TRANSIT EFFECTIVENESS PROJECT Responses to Comments

**City and County of San Francisco Planning Department
Case No. 2011.0558E**

DATE: March 13, 2014
TO: Members of the Planning Commission and Interested Parties
FROM: Sarah B. Jones, Environmental Review Officer
Re: **Attached Responses to Comments on Draft Environmental Impact Report Case No. 2011.0558E Transit Effectiveness Project**

**RESPONSES TO COMMENTS
TRANSIT EFFECTIVENESS PROJECT
PLANNING DEPARTMENT CASE NO. 2011.0558E**

(New) FIGURE 14d - TTRP:9 POTRERO AVENUE TYPICAL BLOCK, 22ND TO 24TH STREETS EXPANDED ALTERNATIVE

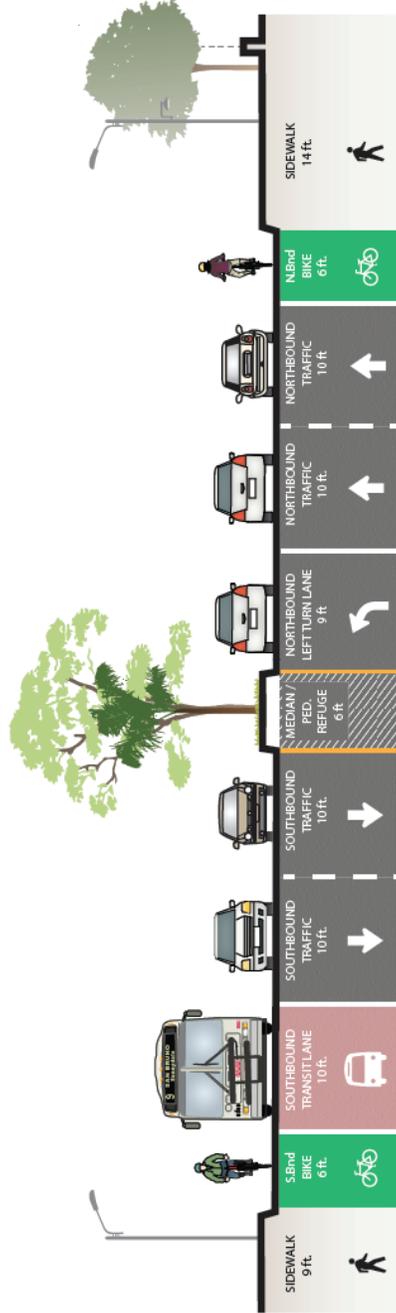
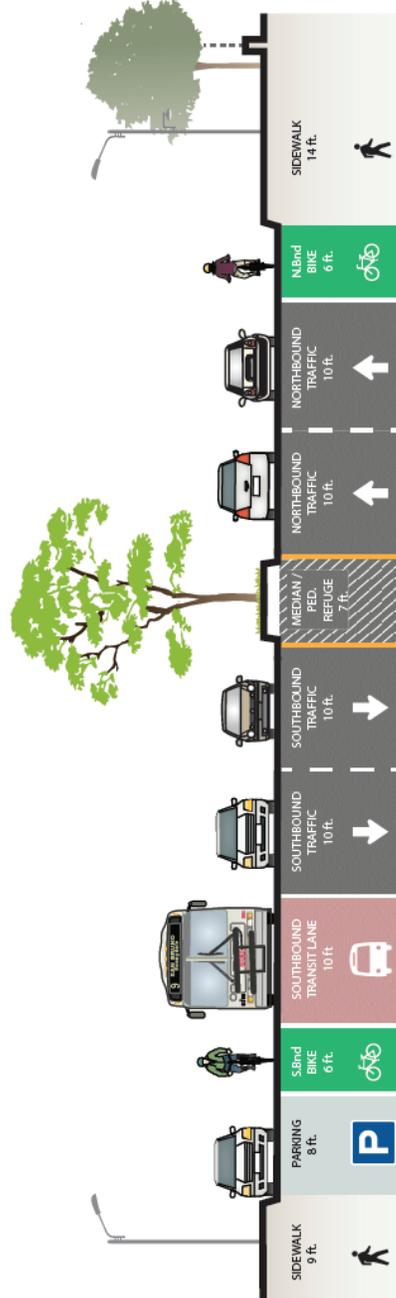
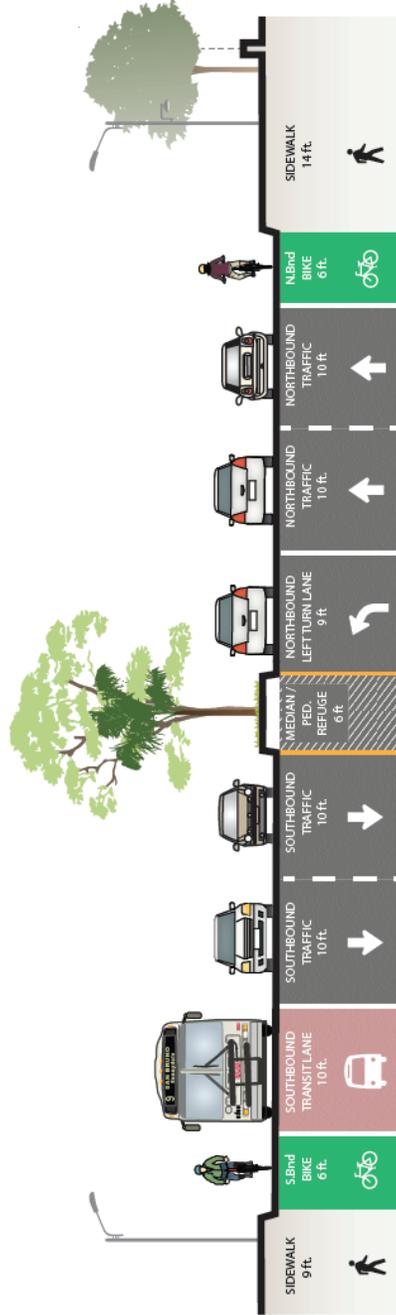
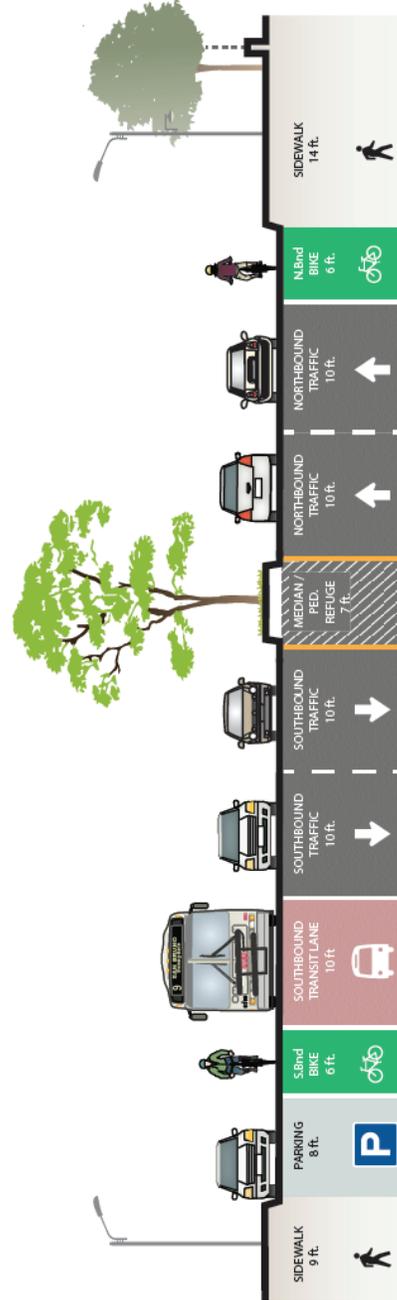
[fnC] Medians illustrated in Figure 14d for the TTRP.9 Expanded Alternative are associated with the median improvements on Potrero Avenue between Cesar Chavez and Division streets planned as part of the Mission District Streetscape Plan Project, San Francisco Planning Department Case File 2008.1075. Available online at http://www.sf-planning.org/ftp/files/MEA/Final_042810_PMDSP_2PM.pdf. Accessed December 10, 2013.

(New) FIGURE 14e - TTRP.9 EXPANDED ALTERNATIVE

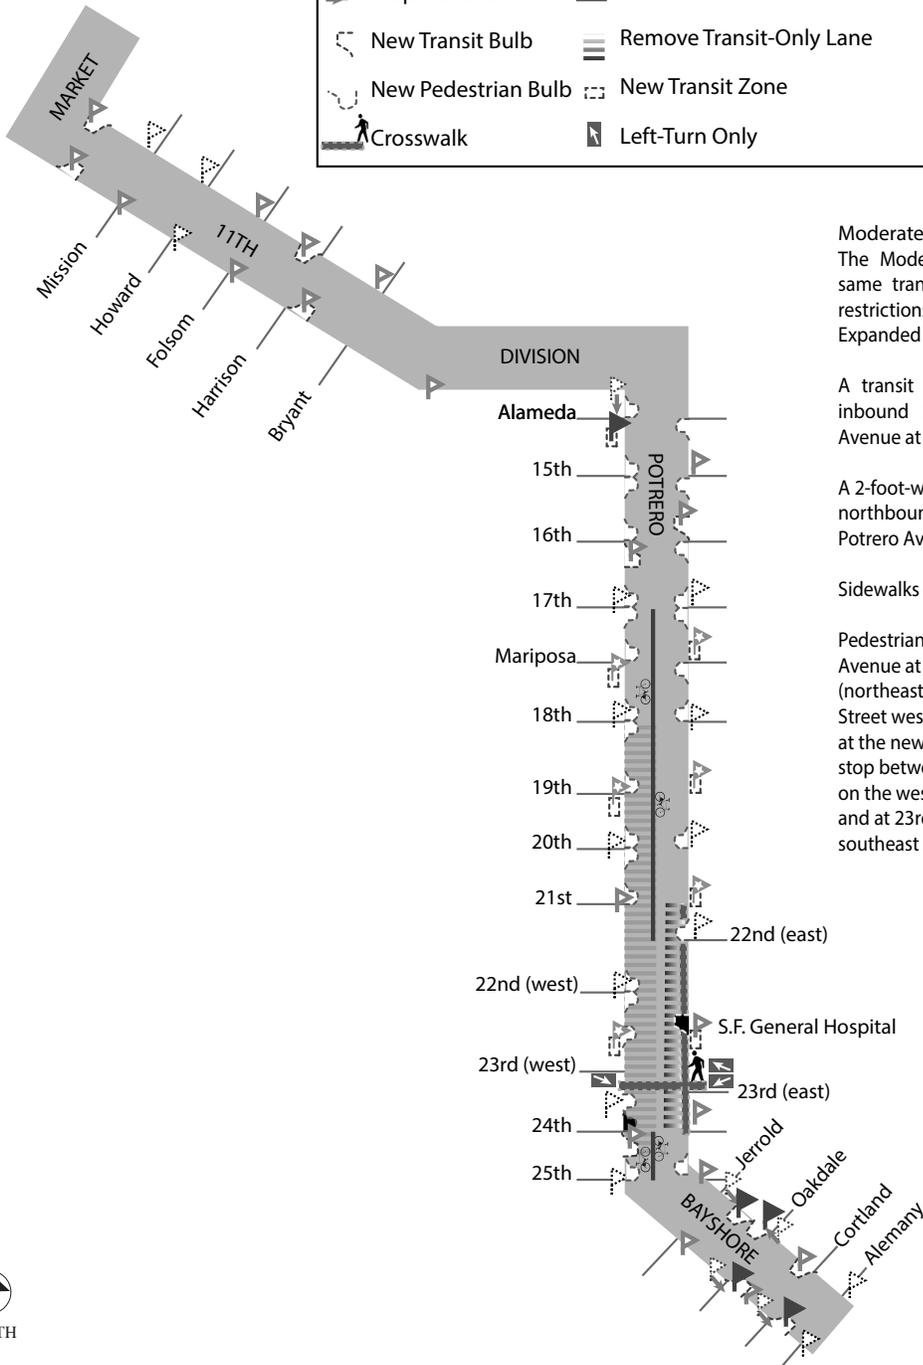
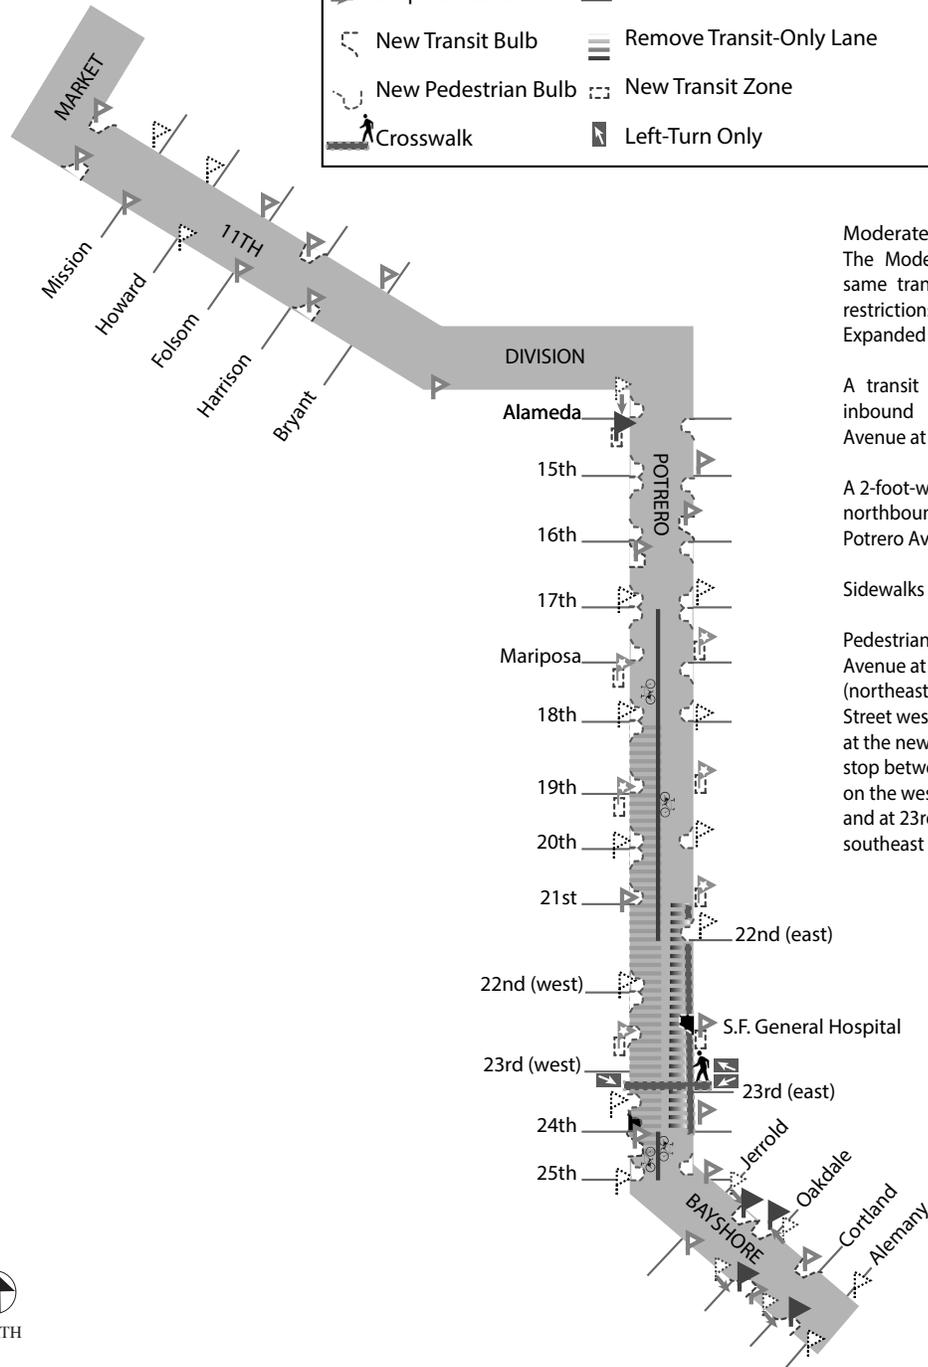
Figure 14e shows the TTRP.9 Expanded Alternative and includes narrative description of the differences between the Moderate and Expanded Alternative.

(Revised) FIGURE 23 - TTRP.30 EXPANDED ALTERNATIVE

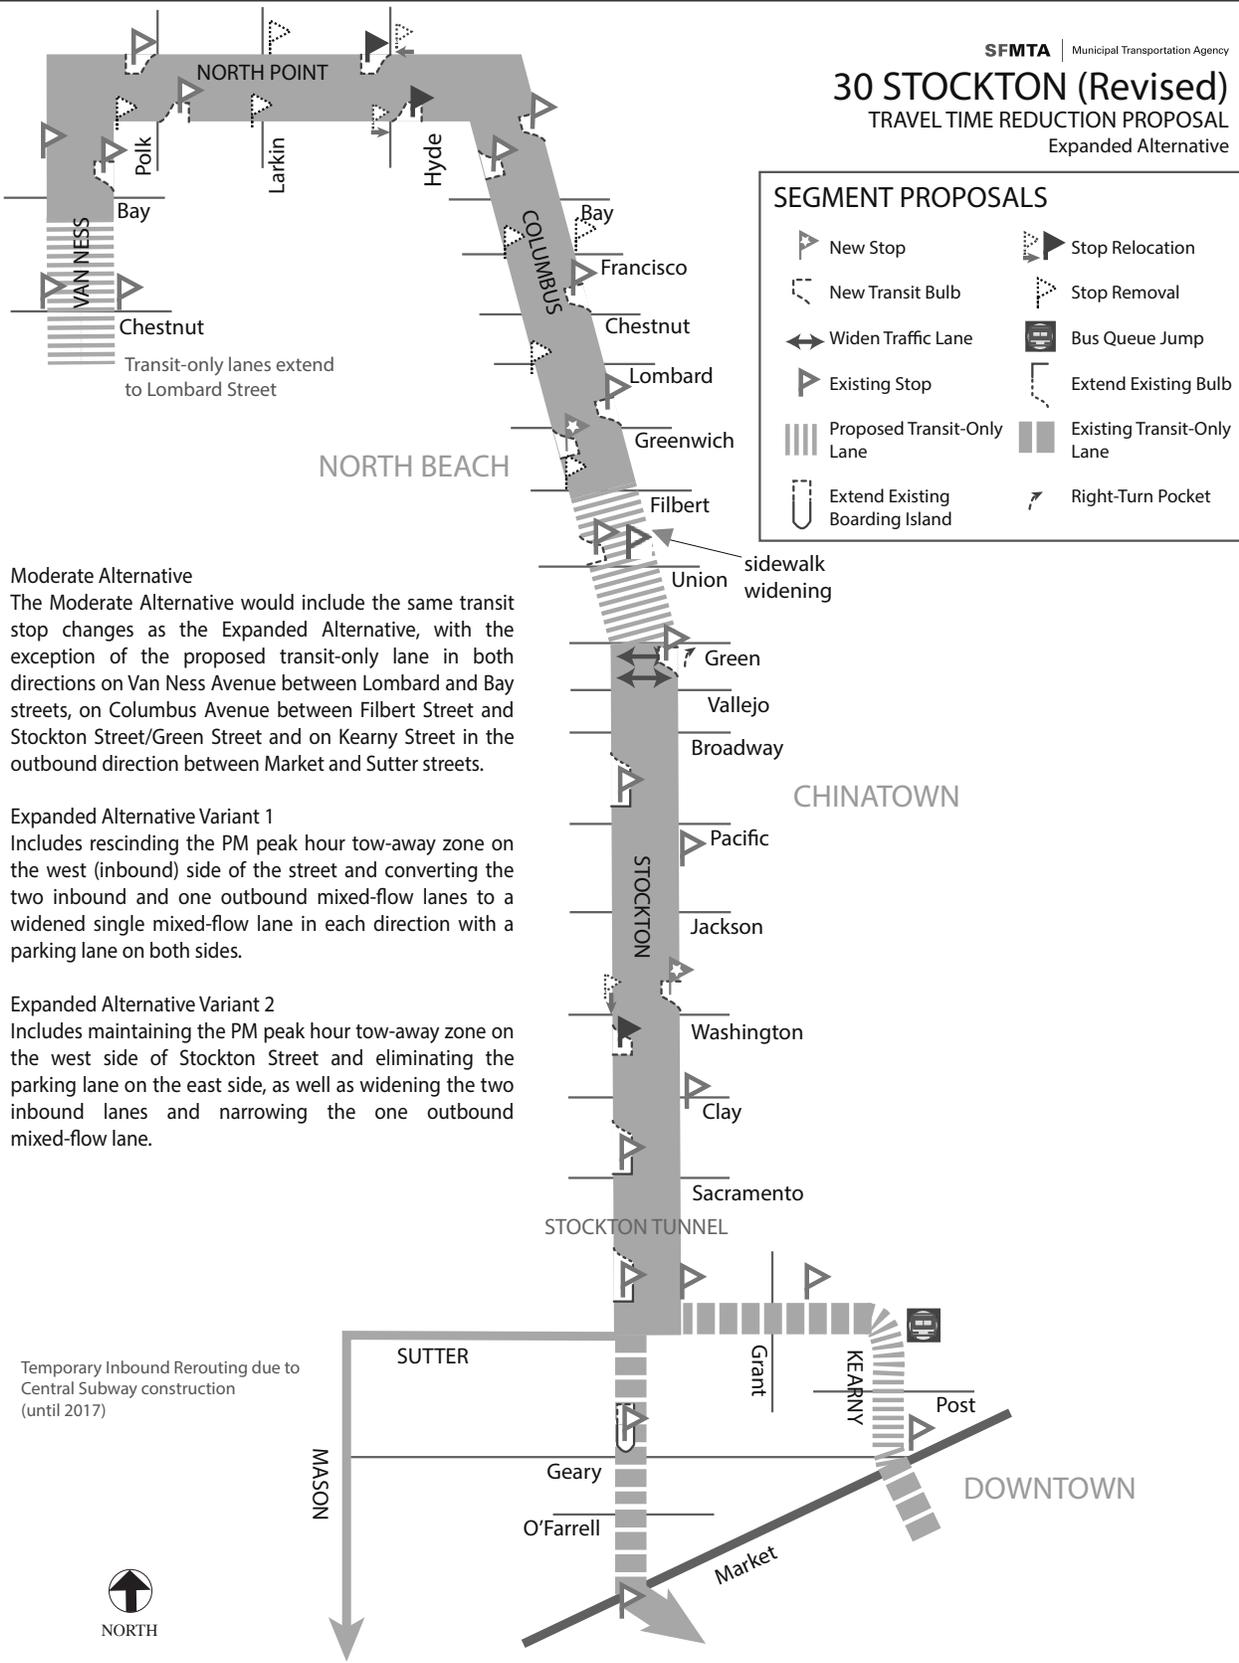
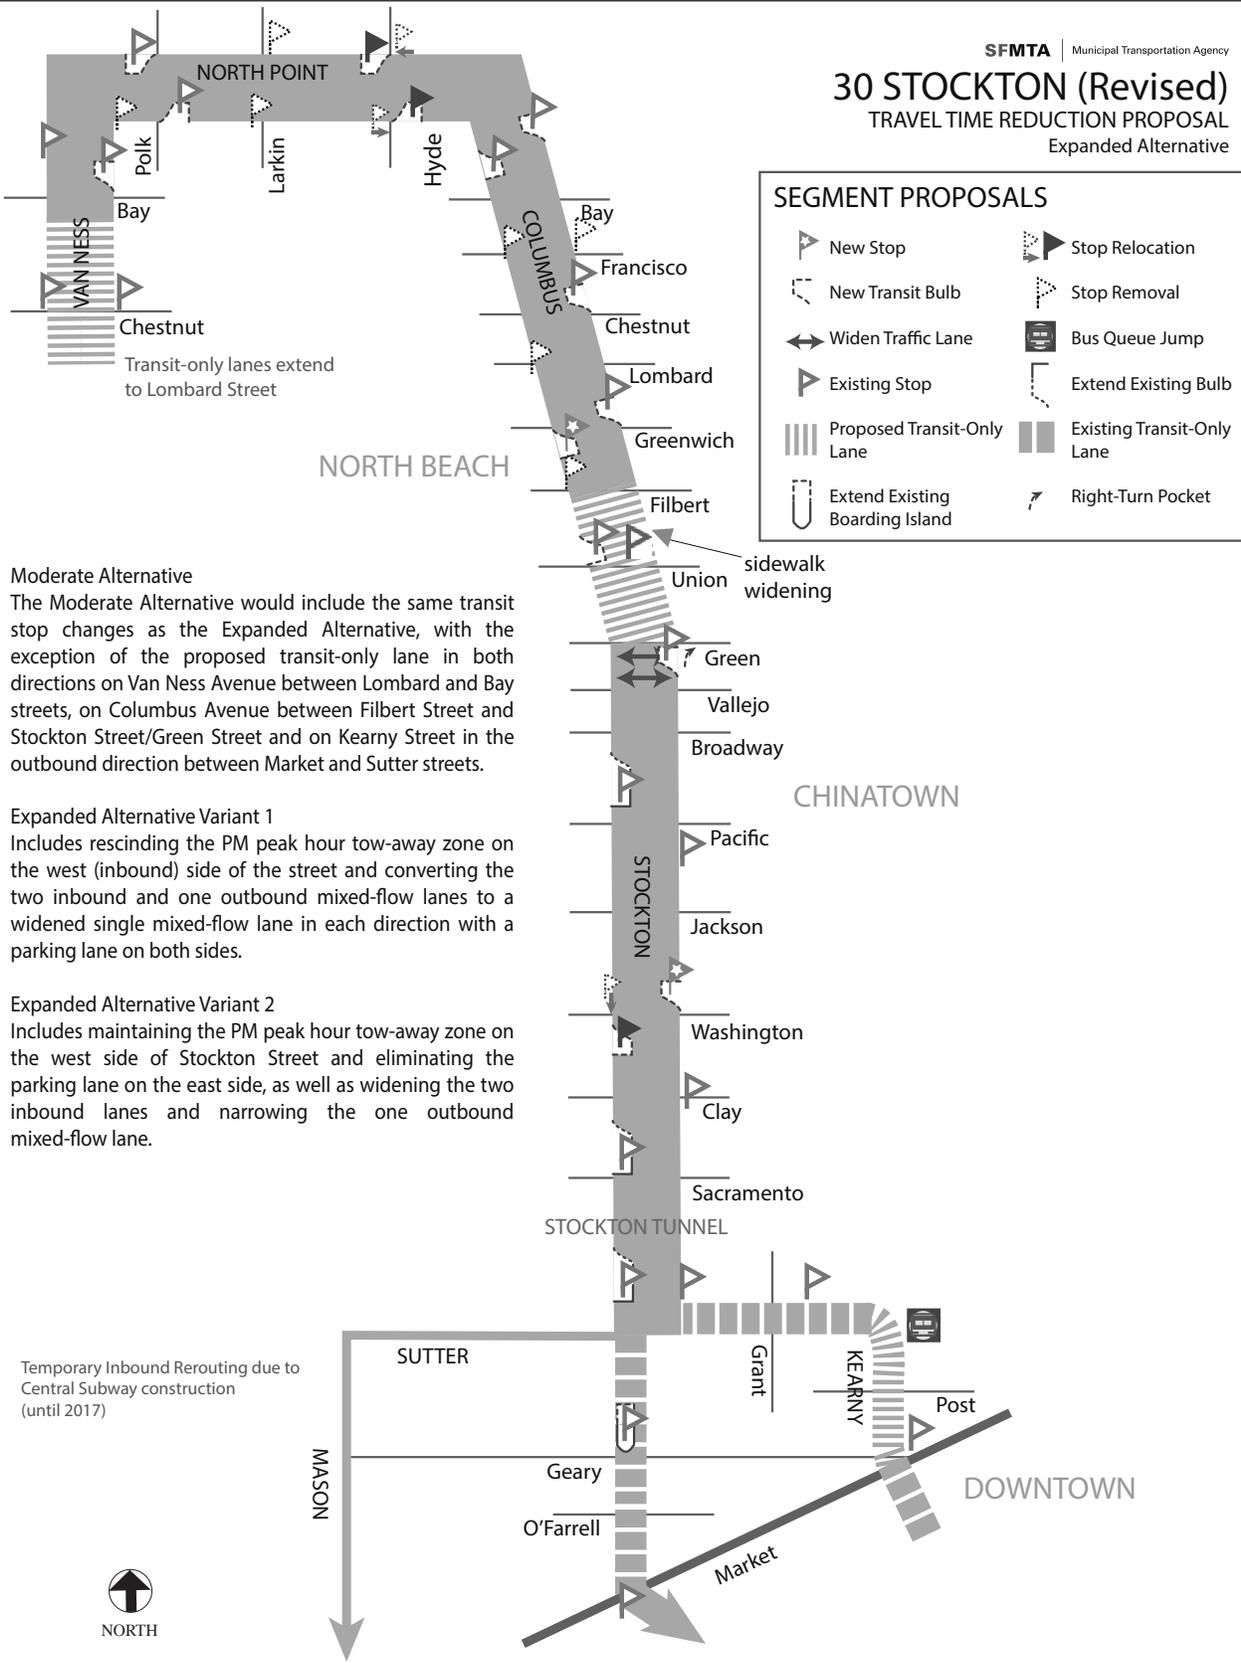
Figure 23: TTRP.30 Expanded Alternative on EIR p. 2-160 has been revised to show that under the Moderate and Expanded Alternatives sidewalk widening would occur on the east side of Columbus Avenue on the entire block between Union and Powell streets. Revised Figure 23 is shown on the following page.

(New) FIGURE 23a - TTRP:71_1 EXPANDED ALTERNATIVE

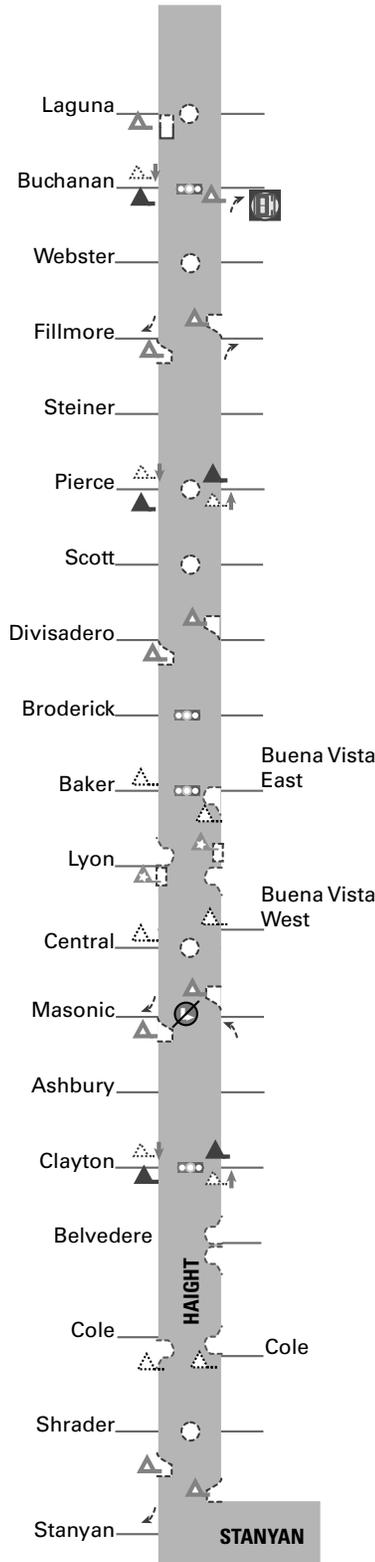
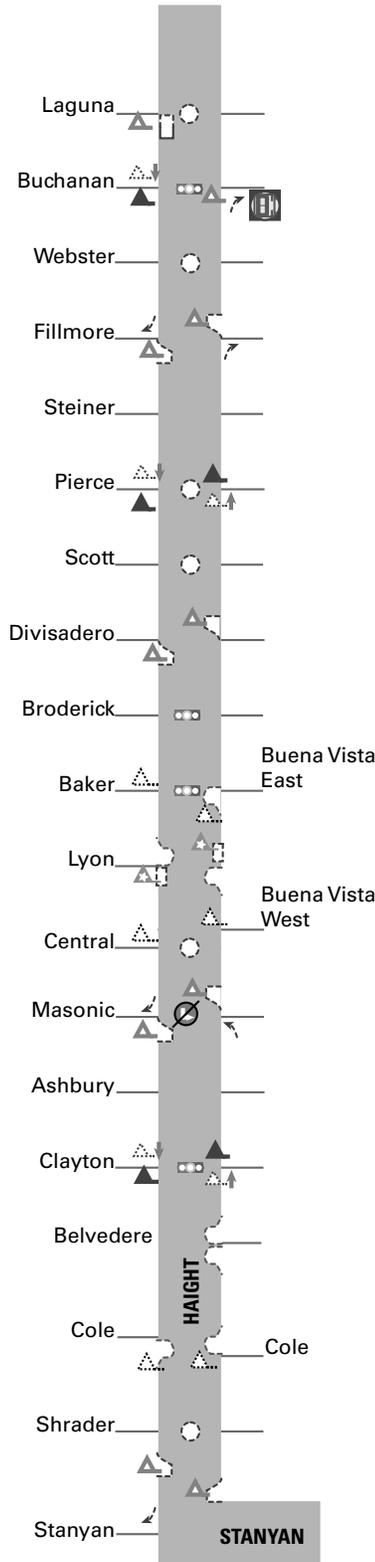
Figure 23a shows TTRP.71_1 Expanded Alternative and describes the differences between the Moderate and Expanded Alternatives. Please see information and additional graphics illustrating the TTRP.71_1 project at the SFMTA Web site, online at <http://www.sftfep.com>.

(New) FIGURE 8c - TTRP.L TRAFFIC CALMING AT TARAVAL STREET AND 42ND AVENUE EXPANDED ALTERNATIVE

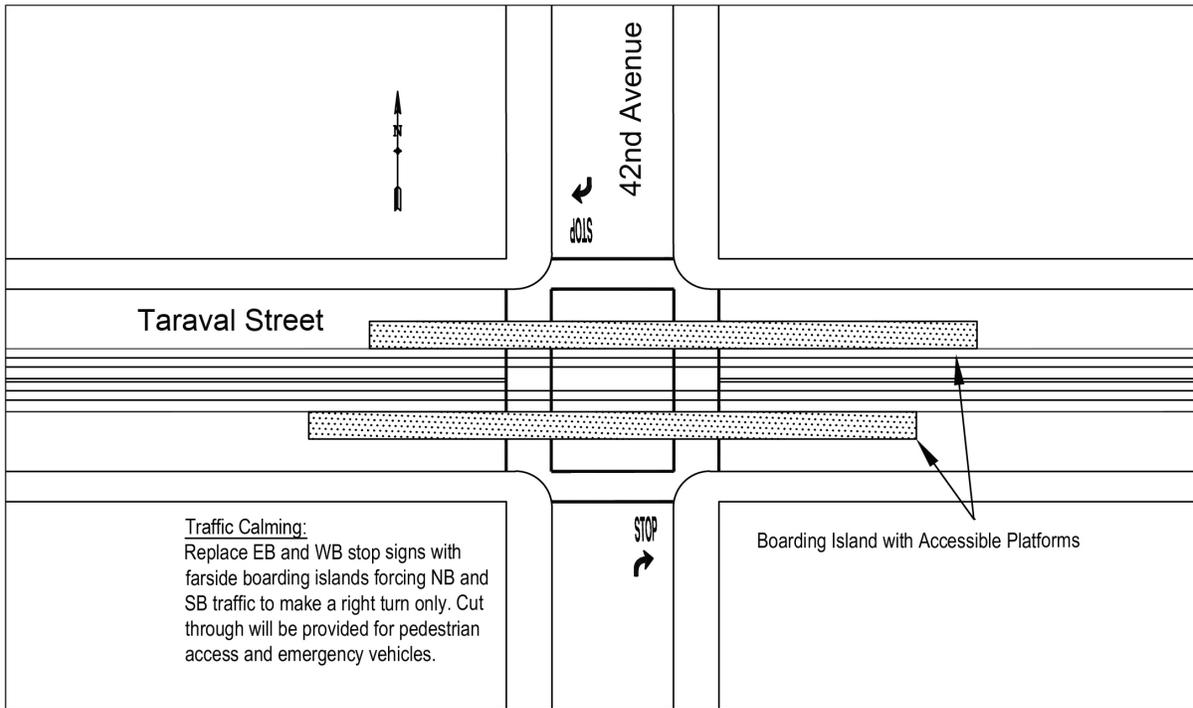
intersection to serve both inbound and outbound directions. Right-turn only restrictions would be added on 42nd Avenue for northbound and southbound traffic. The islands would be designed with a low profile cut-out in the middle that would be wide enough for emergency vehicles to continue through the intersection. Figure 8c shows the proposed change.
